## PCI-SIG ENGINEERING CHANGE NOTICE

<b>TITLE:</b>	PASID Translation
<b>DATE:</b>	March 31, 2011
<b>AFFECTED DOCUMENT:</b>	Address Translation Services Specification, Version 1.1
<b>SPONSOR:</b>	AMD, HP

Figure 2-7: Translation Completion Data Entry

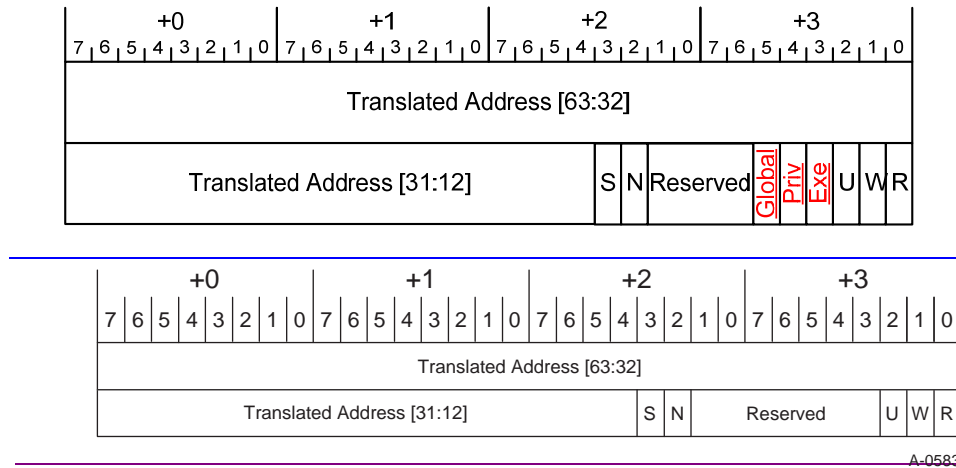
Section 2.3, modify Figure 2-7 to:

- 15
1. Define new bit “Exe” at byte 3 bit 3.
  2. Define new bit “Priv” at byte 3, bit 4.
  3. Define new bit “Global” at byte 3, bit 5.
  4. Shrink the reserved bits to byte 2, bit 1 through byte 3, bit 6.

Figure 3-2: Invalidate Request Message Body

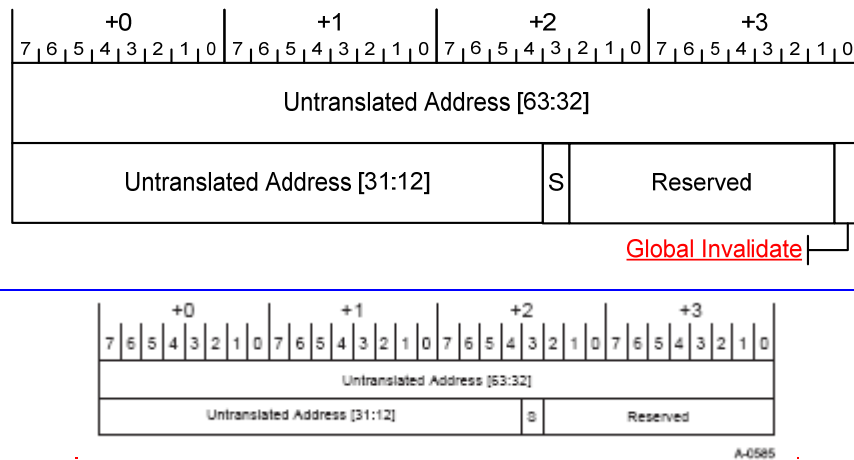
1. Modify Figure 3-2 to new "**Global Invalidate**" bit
2. Add new paragraph at the end of the section

The Global Invalidate bit indicates that the Invalidation Request Message affects all PASID values (see Section 3.8). This bit is Reserved unless the Invalidation Request has a PASID TLP Prefix. The bit is ignored by the ATC if Global Invalidate Supported bits is Clear (see Section 3.8).

**Figure 4-1a: Stop Marker Message**

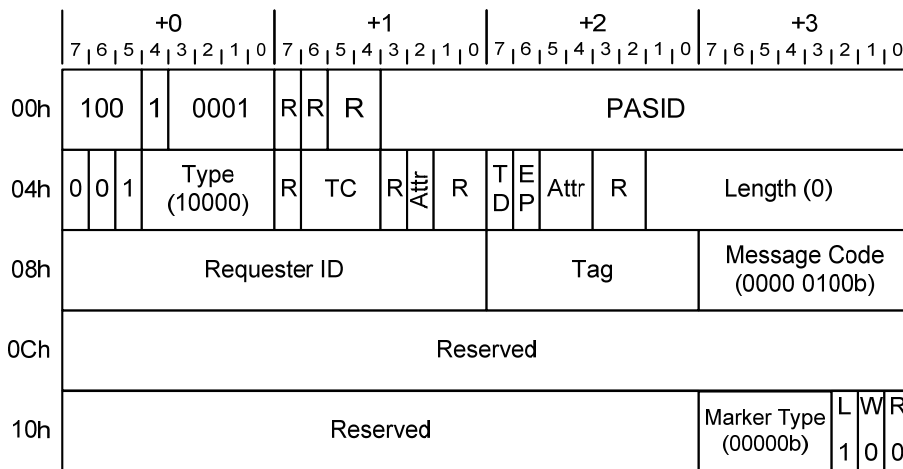
The Stop Marker Message bit layout is shown in Figure 4-1a.

A Stop Marker Message is encoded as a Page Request Message that contains a PASID TLP Prefix with the following exceptions:

- The L, W and R fields contain 1b, 0b and 0b respectively.
- The Untranslated Address field and upper bits of the PRG Index field are Reserved.
- The Marker Type field contains 00000b to indicate that this is a Stop Marker Message.
- The Execute Requested and Privileged Mode Requested bits in the PASID TLP Prefix are Reserved.
- The Traffic Class must be 0.
- The Relaxed Ordering attribute bit must be Clear.
- The ID Based Ordering attribute bit may be Set as specified in the *PCI Express Base Specification*.

Figure 5-3: ATS Capability Register

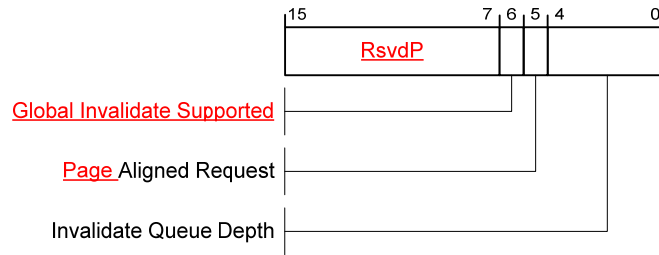
Section 5.1.2, modify Figure 5-3 to:

1. Correct name of bit 5 to **Page** Aligned Request (also noted in ATS Errata)
2. Change reserved bits 15:7 from RsvdZ to RsvdP
3. Define bit 6 as **Global Invalidate Supported**

**Figure 5-8: Page Request Status Register**

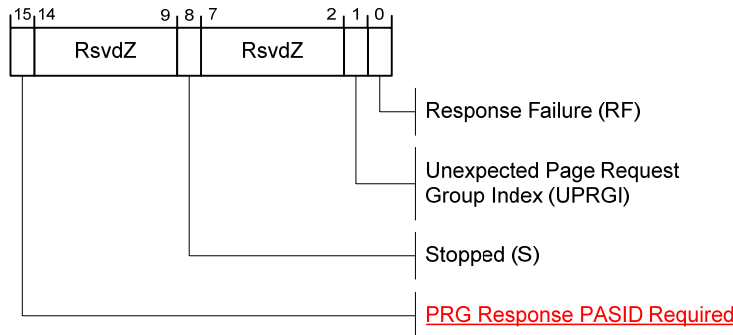
Section 5.2.3, modify Figure 5-8 to define bit 15 as PRG Response PASID Required
